[Crandon Mine Project comments]. Volume 3 1984

Please place the enclosed document with the rest of the Exxon Environmental Impact Report (EIR) material. This item is a copy of Exxon's responses (dated March 16, 1984) to recent Department comments (made during meetings with Exxon on February 29, and March 1, 1984) on the firm's proposed Crandon Mine Project Air Permit Application. Department comments are reiterated in Exxon's response.

CRANDON PROJECT

As per telephone conversations and the meetings with Richard Herbst, Wayne Sadik, and Joseph DeMarte February 29 and March 1, 1984, this letter presents responses to comments from the Bureau of Air Management staff. Since no formal written review comments were submitted to EMC by DNR, we have presented the comments in separate form as recorded in our meeting notes. We believe the major aspects of all the comments are presented and the responses adequately address the content of the comment. Should any of these comments and/or responses not represent adequately the requested information, please notify Richard Herbst as soon as possible.

(Figure for Response to Comment No. 39)

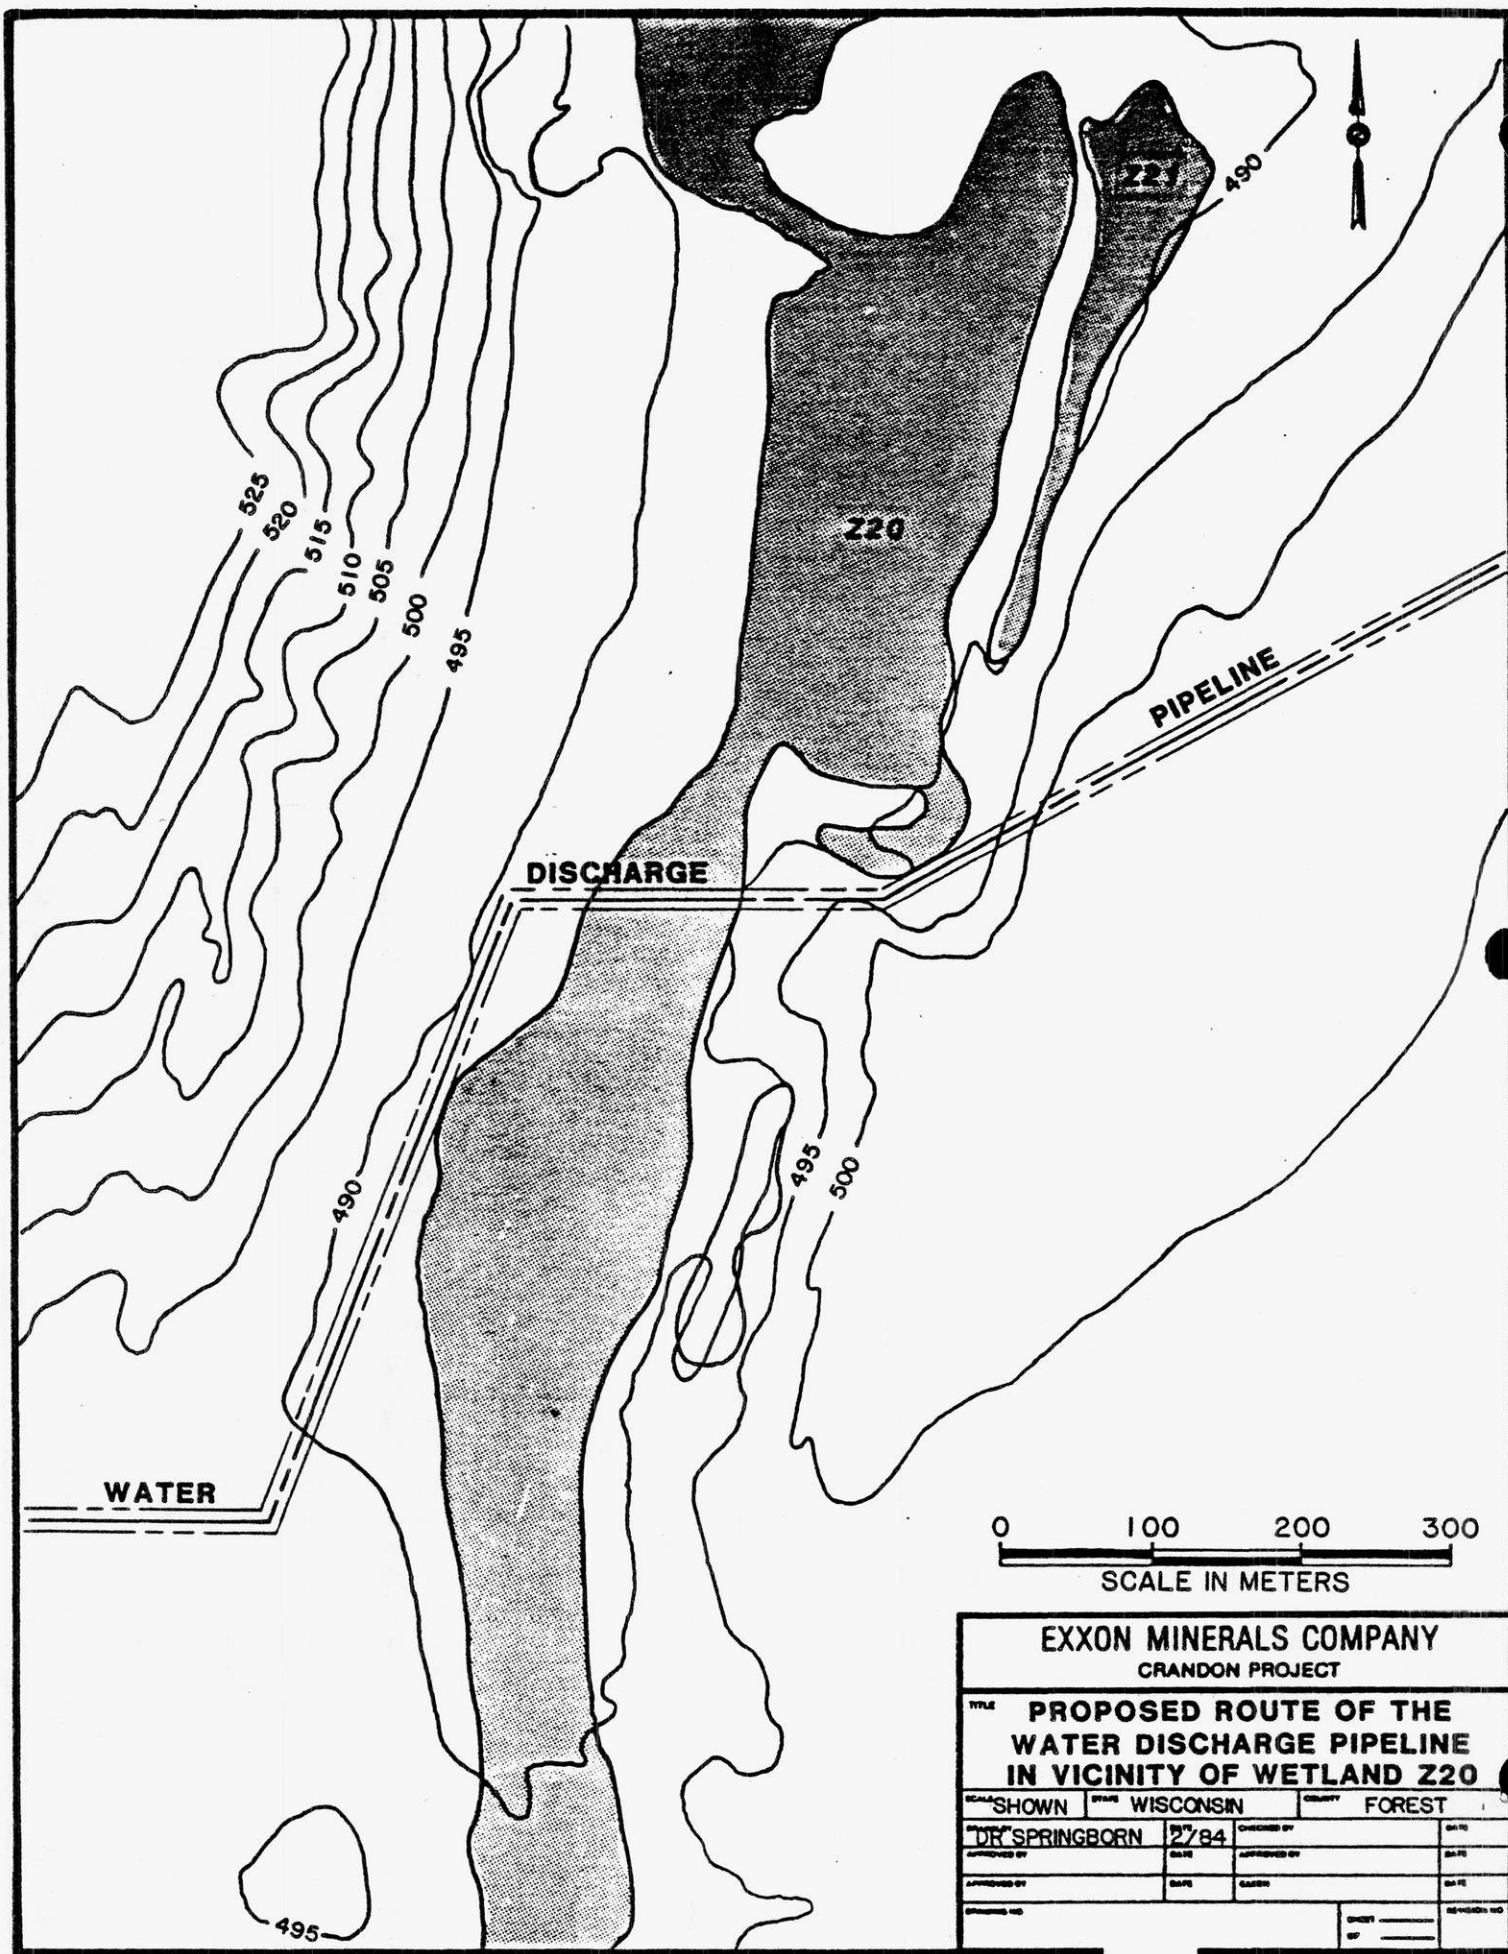
Figure 4.1-13: The discharge pipeline crosses the drainage outlet of Wetland Z-20. The possible effects to this wetland and its outlet from the pipeline construction should be addressed.

The water discharge pipeline will be aligned to minimize impacts to wetland Z20. As shown in the attached figure, the pipeline will be routed so that wetland Z20 is crossed at a narrow point. During construction and installation of the pipeline, less than 0.03 ha (0.09 acre) of wetland Z20 will be affected. To ensure there are no long-term adverse impacts on the hydrologic characteristics of this wetland, as well as other wetlands that may be disturbed during construction of the pipeline, the trench will be backfilled with free draining granular fill materials and the organic soils originally removed during excavation. These materials will allow maintenance of existing surface and subsurface flow conditions through the wetland and there will be no long-term effects on the hydrology of the wetland or its outlet.

(FIGURE 1 FOR RESPONSE TO COMMENT NO. 19.)

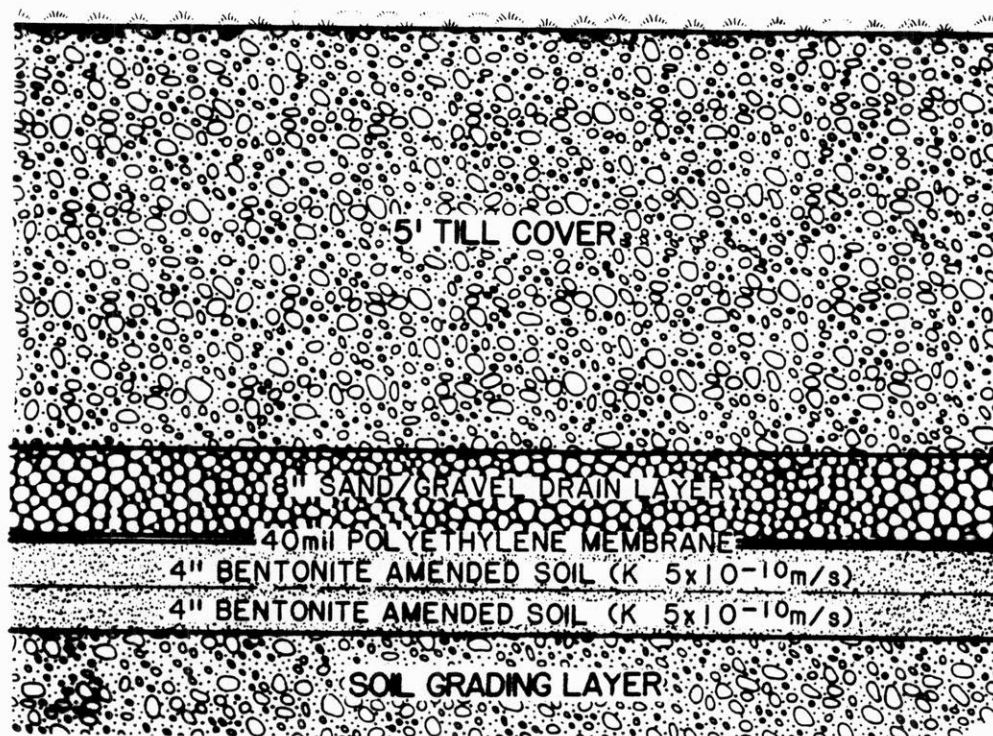
- A. Up to this point, essentially no detail concerning the preproduction ore storage area has been provided. Details of the design, construction, operation, and reclamation of this facility must be discussed.
- B. Any use of this facility for purposes other than preproduction ore storage (e.g., ore surge area or concentrate storage) must also be thoroughly described.

- A. The preproduction ore storage area is designed and constructed with a liner system similar to the tailings ponds (Figure 1) and a peripheral drainage ditch with a permanent collection basin and a sump (Figures 2

(FIGURE 1 FOR RESPONSE TO COMMENT NO. 29.)

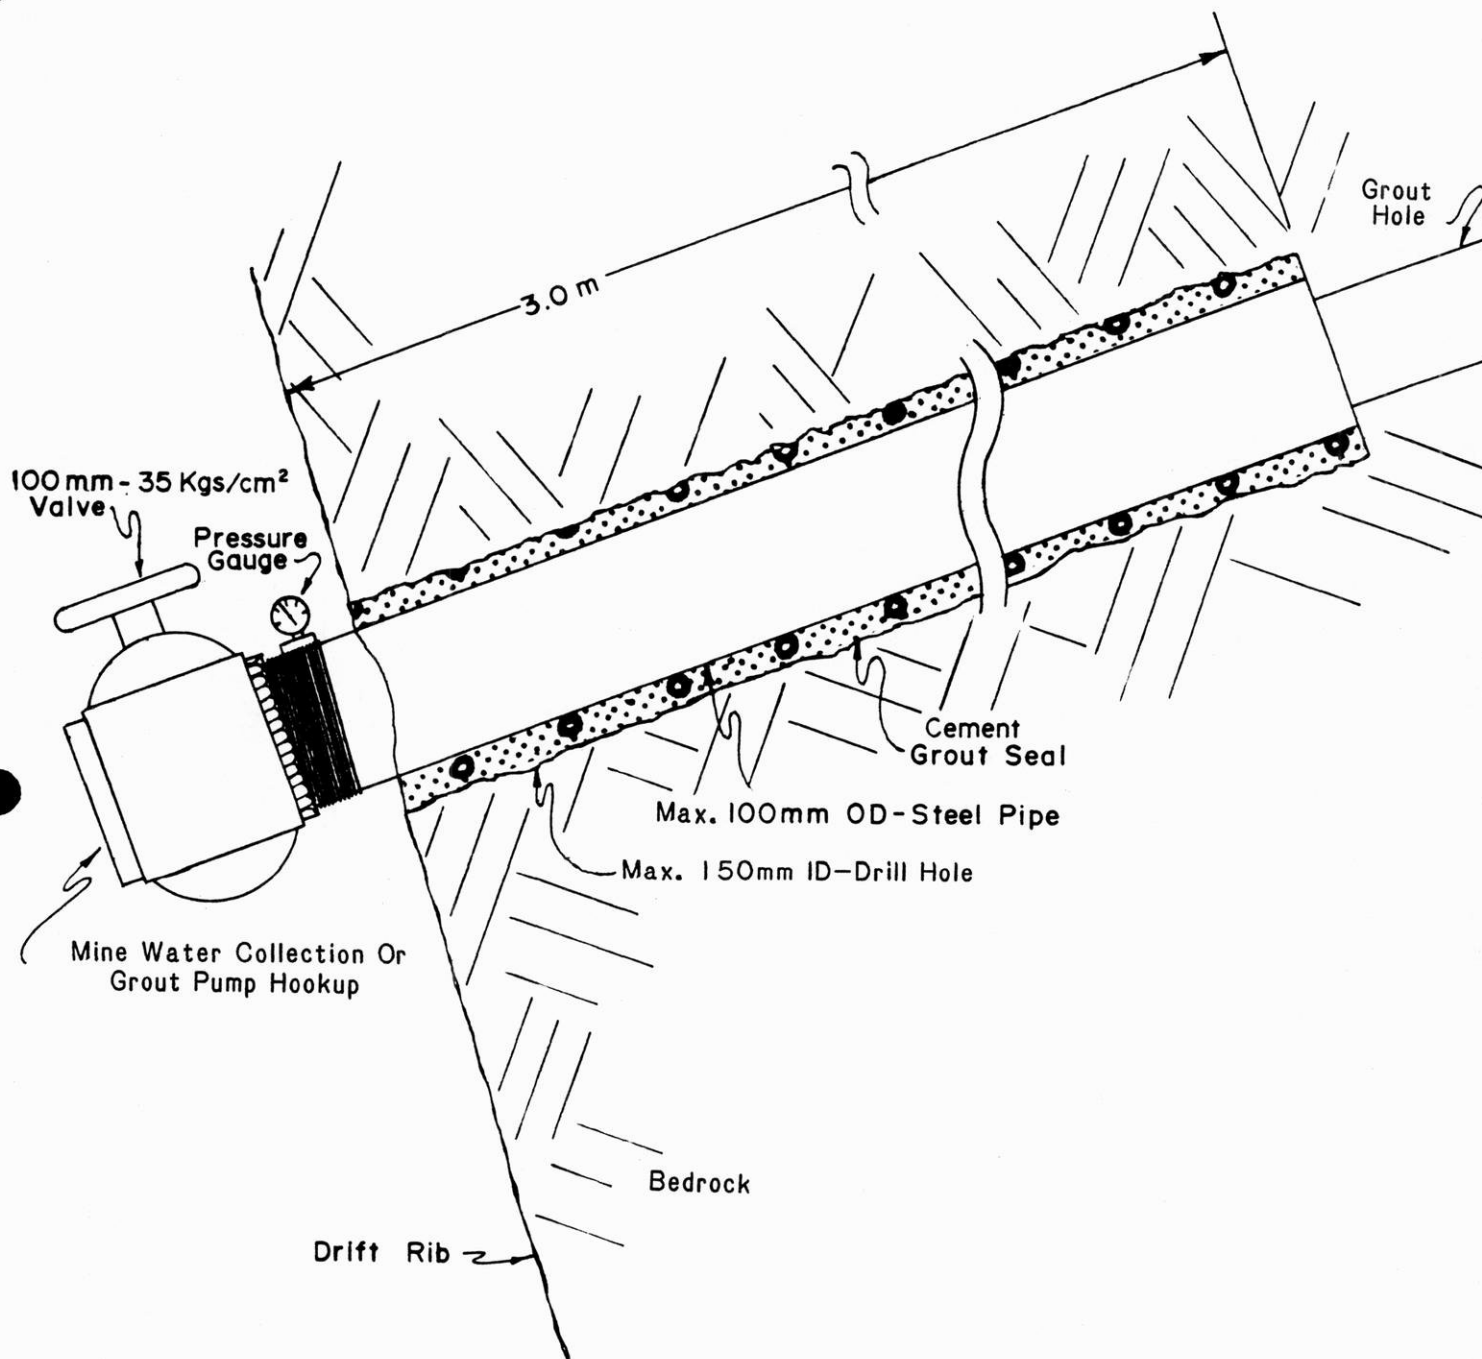
Will the ground water interceptor drill holes be plugged once mining ceases? A diagram of a typical grout well, showing diameter, method of construction, grouting, etc. should be provided. When and how will these holes be abandoned?

Drill holes located in the uppermost active mining levels to intercept and contain inflowing ground water prior to potential contamination by contact with the mining processes will typically be outfitted as indicated on Figure 1. Such drill hole collar manifolds will facilitate ground water collection, provide for ground water inflow monitoring, and ultimately serve as the preparation for drainage hole abandonment.

(FIGURE 1 FOR RESPONSE TO COMMENT NO. 30.)

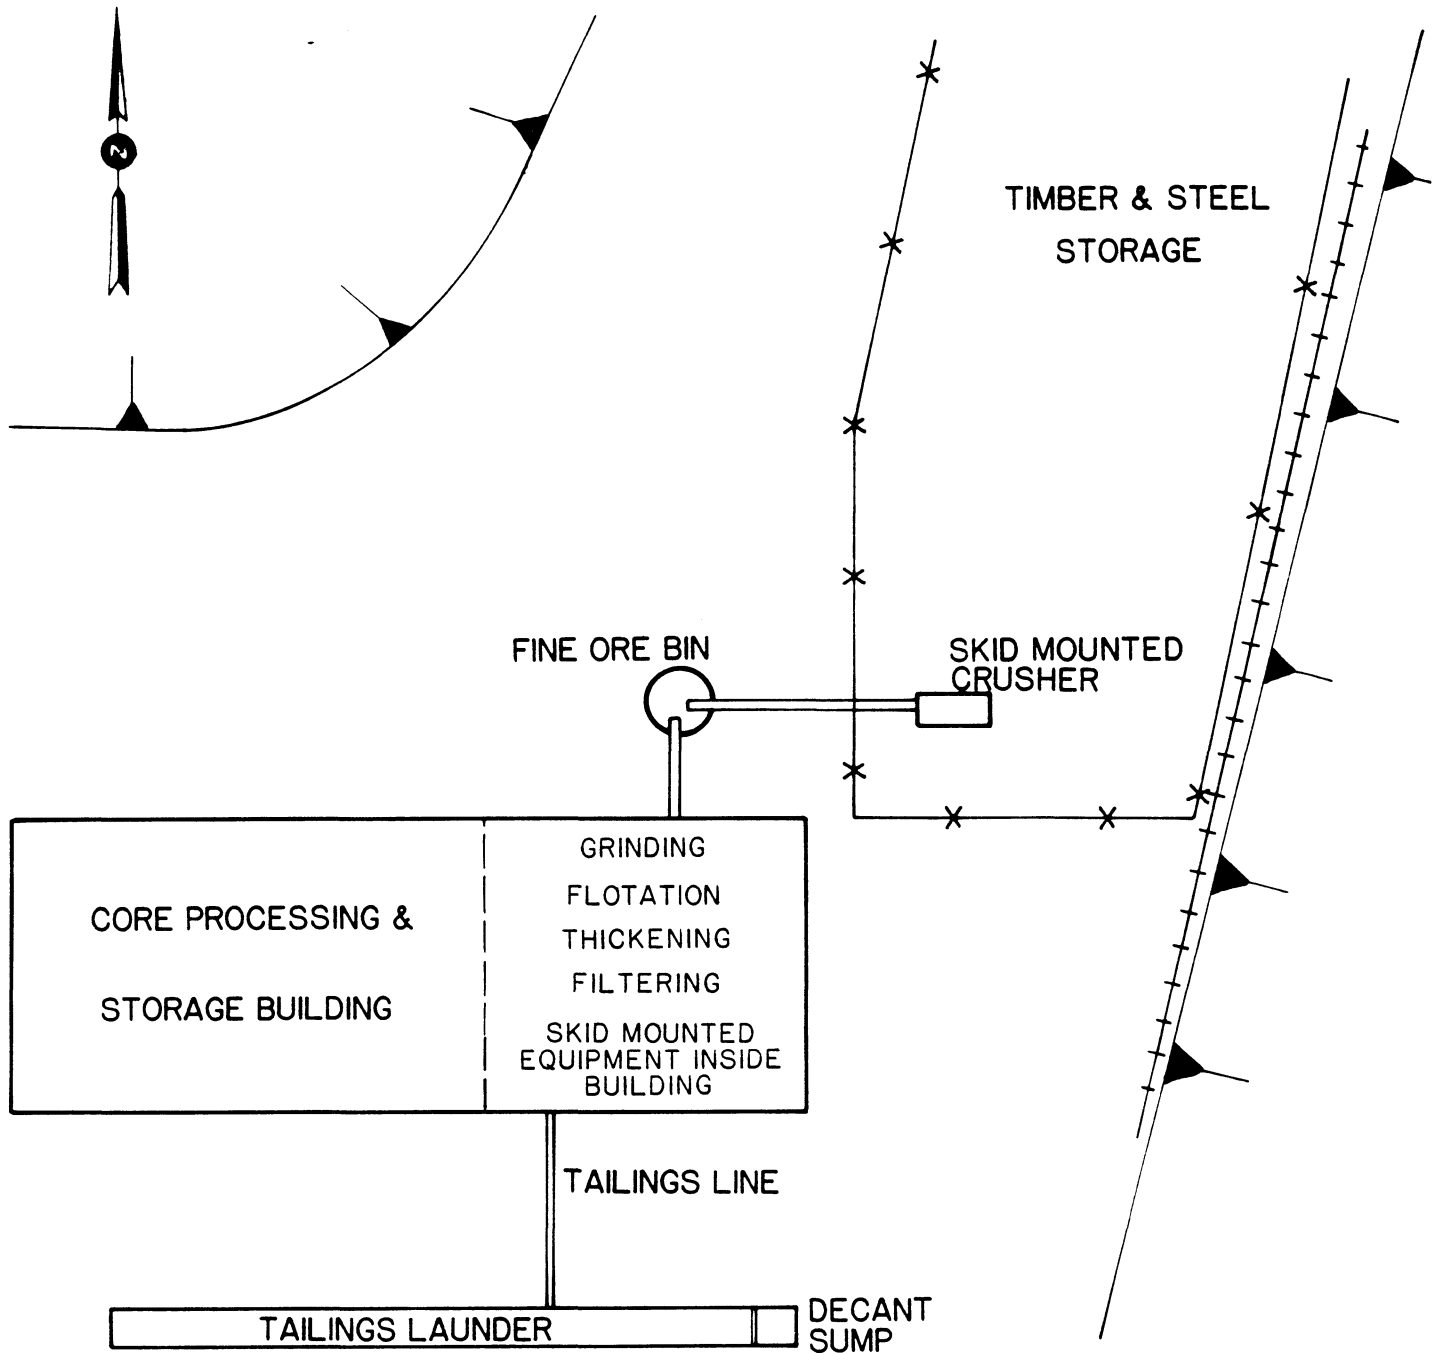
The plans and specifications for dust collection and ventilation for the testing and training facility will be reviewed when they are submitted.

The preliminary engineering for the Pilot Plant (i.e., testing and training facility) is complete and a schematic drawing of the facility arrangement is attached (Figure 1). Process rates and resultant TSP emission rates for various steps in the process were determined and indicate that ventilation ducting and collecting are not warranted. Adequate control will be realized from enclosure or water spraying at dust emitting points in the process. The TSP emission estimates are also attached (Table 1).
